Appendix M2
Road Safety Audit
Stage 1

This report results from a Stage 1 Road Safety Audit of the CBC02 Swords to City Centre Core Bus Corridor.

Figure 2.1 Ponding of water in the carriageway (Ch A4650)

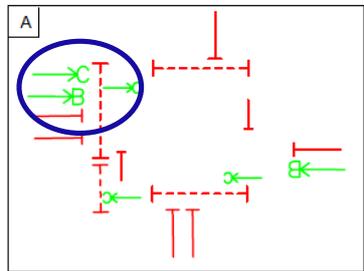
The Audit Team noted on site the ponding of water in the carriageway at various locations. The widening of the carriageway to facilitate additional lanes may increase the risk of ponding of water and increase the risk of loss of control type collisions due to ice during cold conditions

The Design Team should ensure the drainage design is sufficient to positively drain the carriageway.

Figure 2.3 Swords Road/
Northwood Avenue

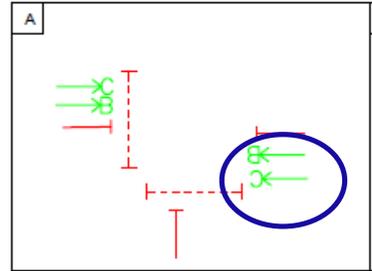
The Audit Team note that at some junctions, the signal phasing indicates that the cyclist 'green' movement proceeds at the same time as the bus lane 'green'. The Audit Team note that the cycle stop line is placed ahead bus stop line but is concerned that where the bus lane is used by taxi or private coaches to undertake a left turn movement and are unaware of the need to yield to cyclists crossing, increasing the risk of cyclist and vehicular conflicts.

The Design Team should ensure that the signal phasing for the Bus Lane and Cyclist movements are independent where a left turn is involved.

Figure 2.5 Swords Road/ Boroimhe Road

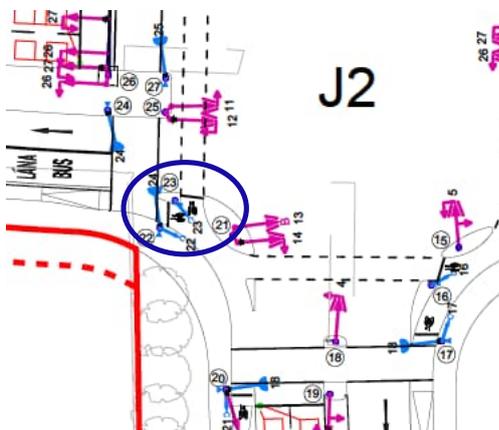
The drawings indicate the provision of cycle lights in close proximity within the junction in various locations. There is concern that the alternative green phase of these lights will cause cyclists confusion putting them into conflict with either vehicular traffic or other vulnerable road users.

The Design Team should ensure cycle signals and associated stop lines are located in such a way not to cause confusion.

Figure 3.7 Existing access to Industrial Estate

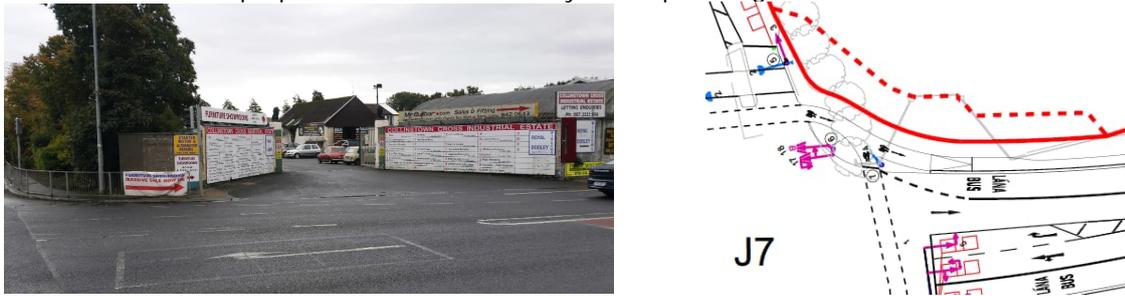
The Audit Team are concerned that the proximity of the Collinstown Cross Industrial Estate to the proposed junction. From the drawings provided it is unclear whether the existing junction is to be retained or where an alternative access is proposed. It is noted that a cycle ramp and signal is located at the mouth of the entrance

Figure 3.9 Conflict between cycle ramp and existing entrance

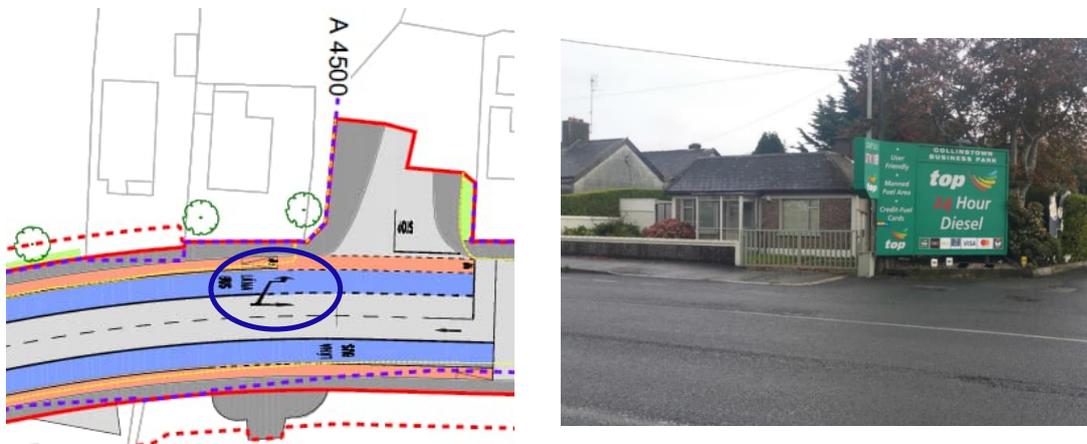
The Audit Team are concerned that the proposed cycle ramp kerbing at chainage A4500, will inhibit access to an existing entrance. Motorists may be unaware of the presence of kerbing leading to loss of control type collisions.

Figure 3.18 Safe routes to School

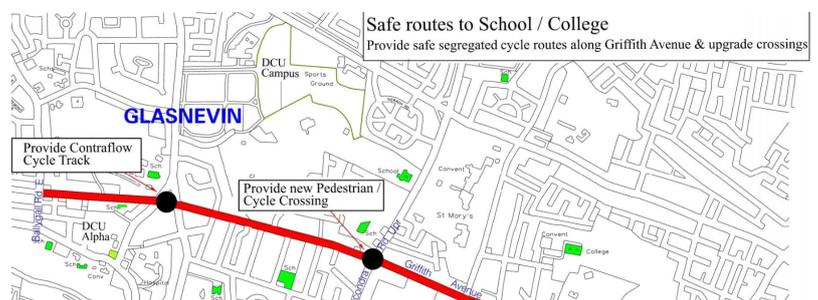
The Audit Team observed that a on road cycle lane has been developed along Griffith Avenue as part of a safe routes to school initiative by Dublin City Council. It's unclear from the drawings provided how this scheme will tie into the off road cycle lane on the Griffith Avenue/ Swords Road junction.

Figure 3.21 Existing driveway

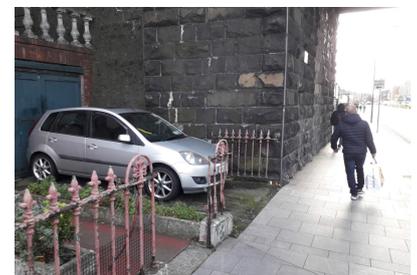
At chainage A10600, the Audit Team is concerned that the proposed bus stop may restrict access to an existing driveway on the eastern side of the Drumcondra Road Lower.
